SUBJECT: DEMONSTRATION / DELIVERY HOLD - Safety Recall 16S30 - *Supplement #4*
Certain 2013-2015 Model Year C-MAX and Escape, 2012-2015 Focus, 2015 MKC
and Mustang, and 2014-2016 Transit Connect Vehicles
Side Door Latch Replacement

New! REASON FOR THIS SUPPLEMENT

DEMONSTRATION / DELIVERY HOLD - Safety Recall 16S30 - Supplement #4

FIGURE 2

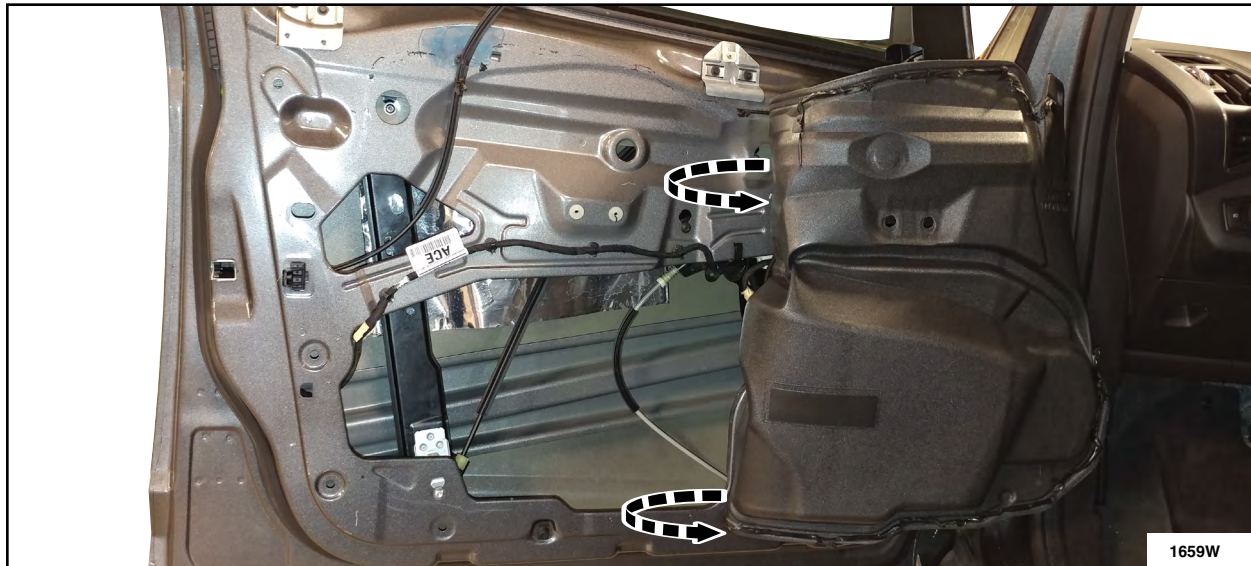
- The repair procedures for C-MAX and Focus are updated to eliminate unnecessary steps.*

NOTE: For front door latch replacement, it is not necessary to remove the door modules, speakers, or water shield. To access components for removal, position aside the water shield as needed. See Figure 2.

1. Replace the front and rear side door latches. Please follow the Workshop Manual (WSM) procedures in Section 501-14.
